CITY OF ALBUQUERQUE

Re: Clean Machine Carwash #4
4200 San Mateo Blvd., NE
Traffic Circulation Layout
Engineer's/Architect's Stamp **4-28-16** (G18-D049)

Based upon the information provided in your submittal received 4-29-16, the above referenced plan cannot be approved for Building Permit until the following comments are addressed:

SITE PLAN

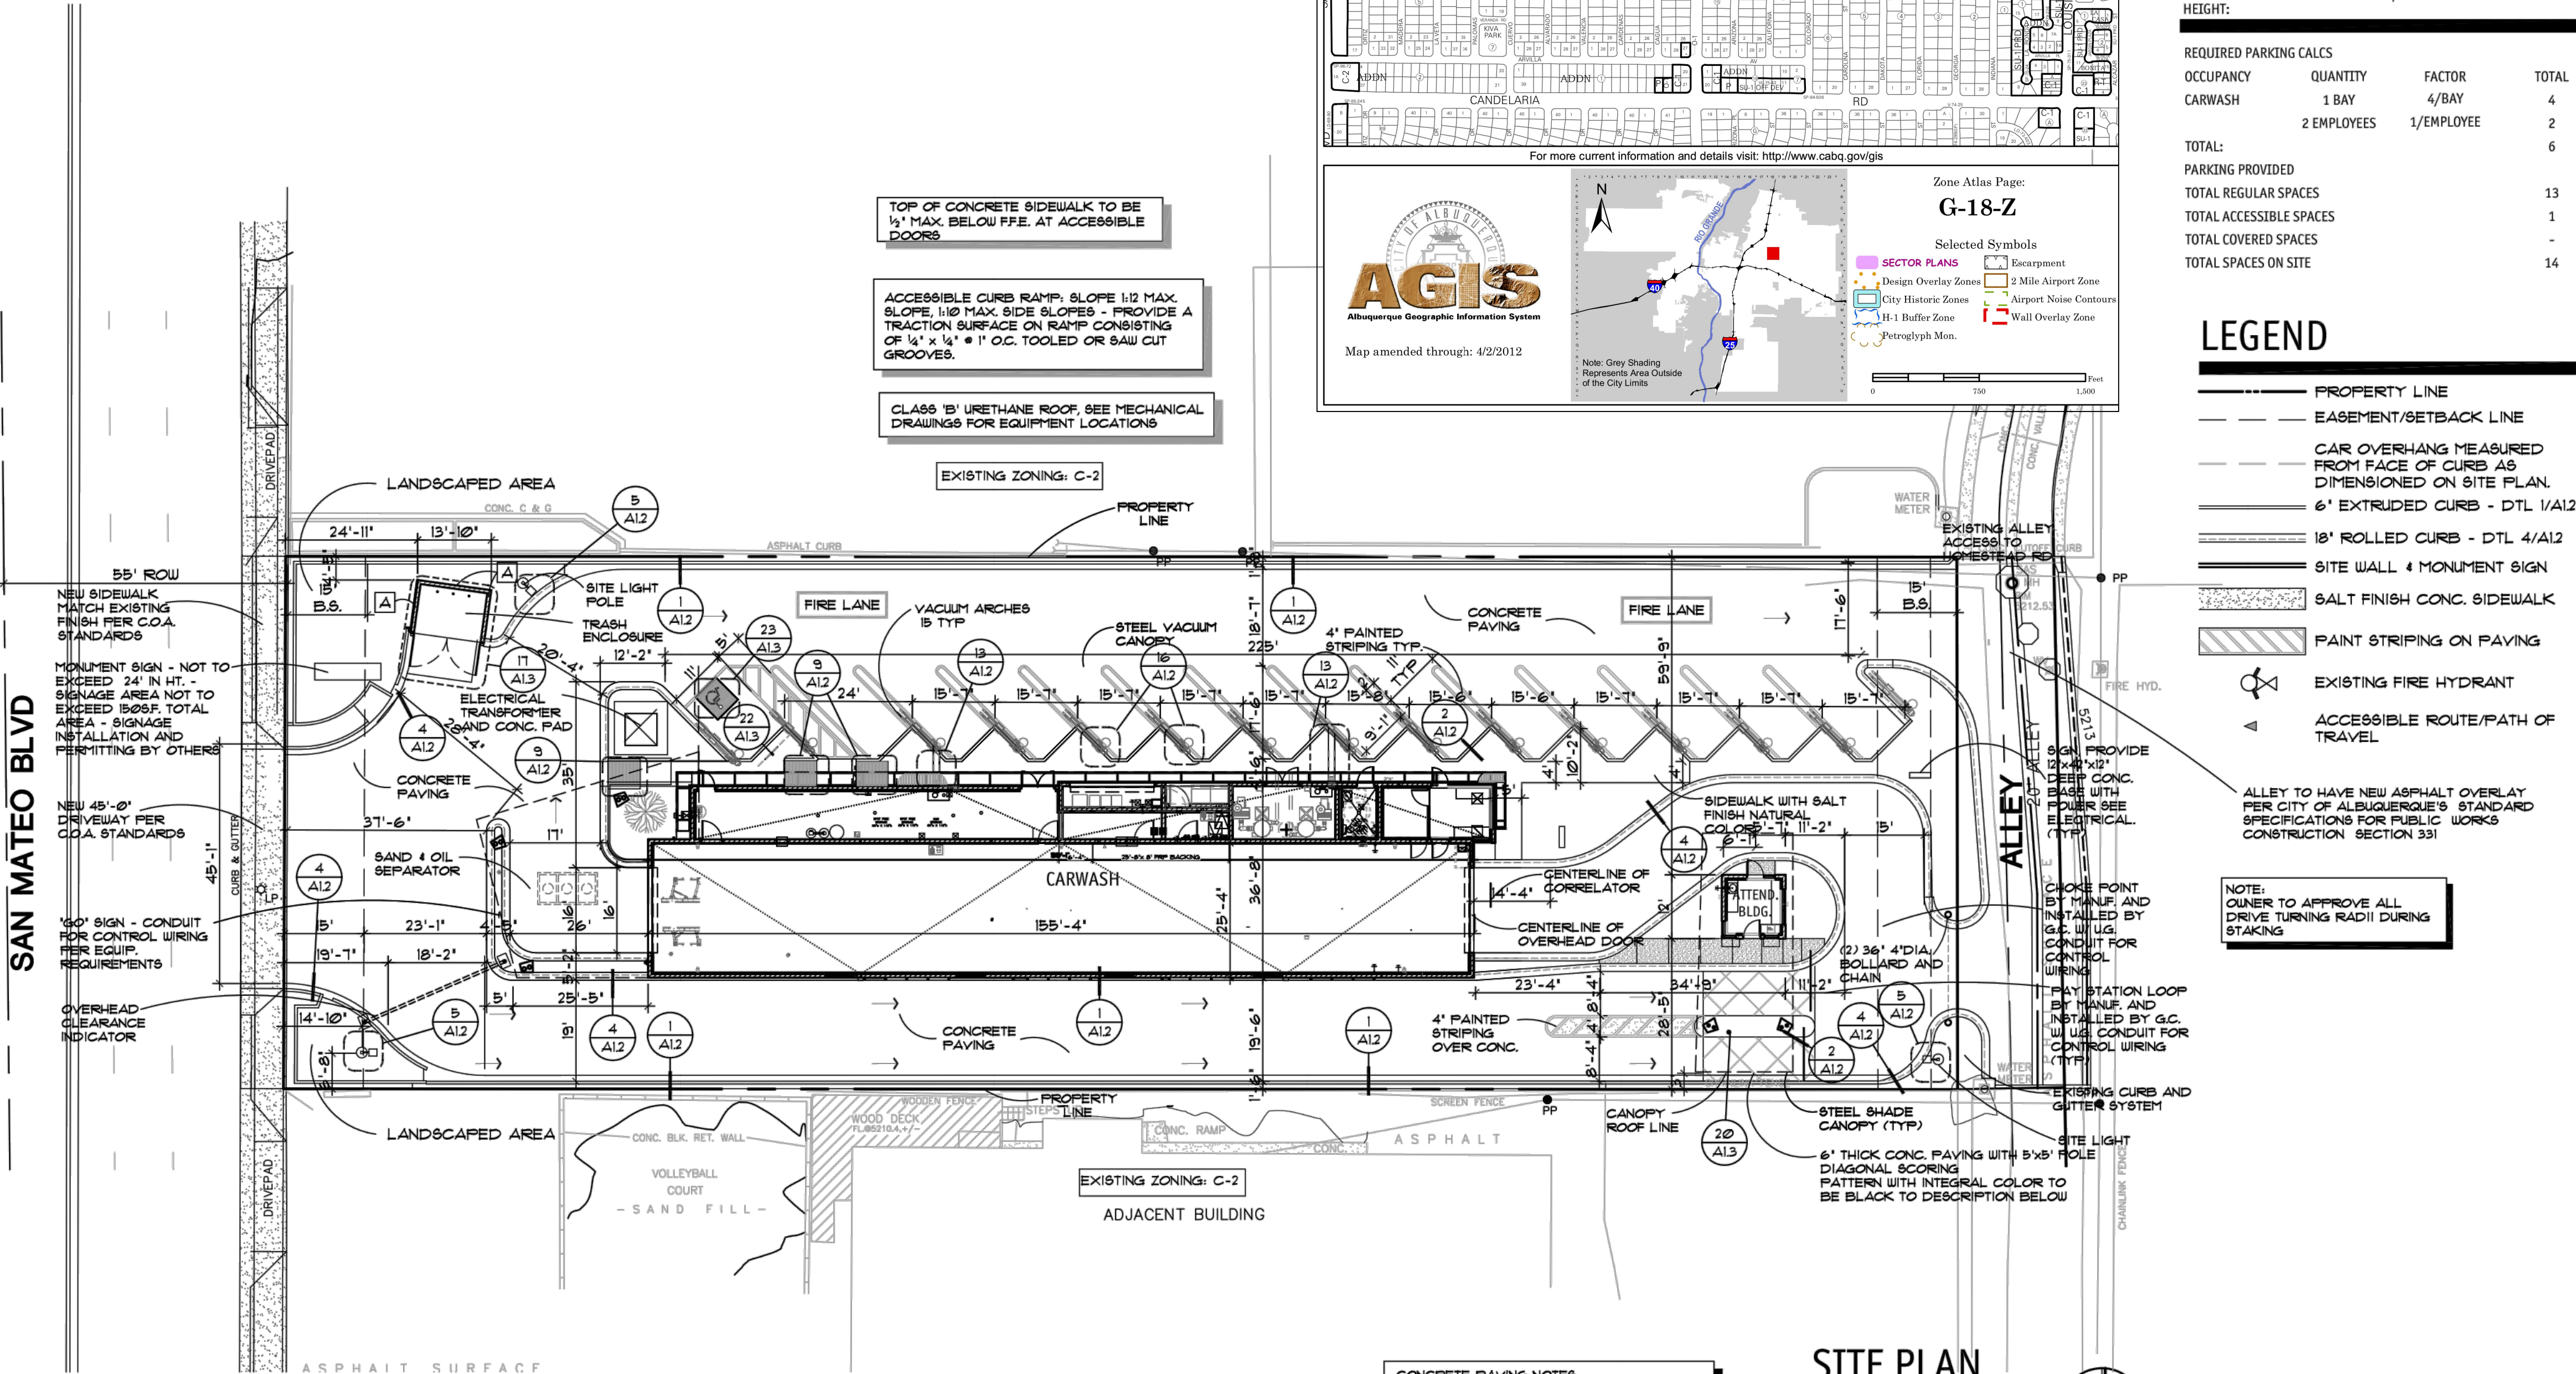
1. Dimension and detail all existing and proposed drive lanes, drive pad entrances/exits, sidewalks and ADA ramps.
2. Per DPM, the drive through lane width must be 12 ft. wide per vehicle. In review of the submitted drawing, there is only 8 ft. 4 in. provided for each drive isle entering the carwash bay area.

3. Please provide the queuing distance.
4. The ADA accessible parking sign must have the required language per 66-7-352.4C NMSA 1978 "**Violators Are Subject to a Fine and/or Towing.**" Please call out detail and location of HC signs.

5. Show all drive aisle widths and radii.
6. List radii for all curves shown; for passenger vehicles, the minimum end island radius is 15 ft. Landscape island radius for delivery trucks, fire trucks, etc. is 25 ft. or larger.

7. Per DPM, a 6 ft. wide ADA accessible pedestrian pathway is required from the public sidewalk to the building entrances. Please clearly show this pathway and provide details from San Mateo Blvd.

8. Per DPM, a 6 ft. wide ADA accessible pedestrian pathway is required from the HC parking stall access aisles to the building entrances. Please clearly show this pathway and provide details.

9. Provide a min 6" or max 8" high concrete barrier curb or other acceptable barrier between landscaping and parking areas and/or drive aisles. Please call out detail and location of barrier curb.

10. Design delivery vehicle route needs to be shown.
11. Service vehicle and/or refuse vehicle maneuvering must be contained on-site; provide a copy of refuse approval.

12. One-way vehicular paths require pavement directional signage and a posted **"Do Not Enter"** sign at the point of egress. Please show detail and location of posted signs.

13. Please provide a sight distance exhibit (see the *Development Process Manual, Chapter 23, Section 3*).
14. Please add the following note to the clear sight triangle: "Landscaping and signage will not interfere with clear sight requirements. Therefore, signs, walls, trees, and shrubbery between 3 and 8 feet tall (as measured from the gutter pan) will not be acceptable in this area."

15. Unused curb cuts must be replaced with sidewalk and curb & gutter. A build note must be provided referring to the appropriate City Standard drawing.

16. All broken or cracked sidewalk must be replaced with sidewalk and curb & gutter. A build note must be provided referring to the appropriate City Standard drawing.
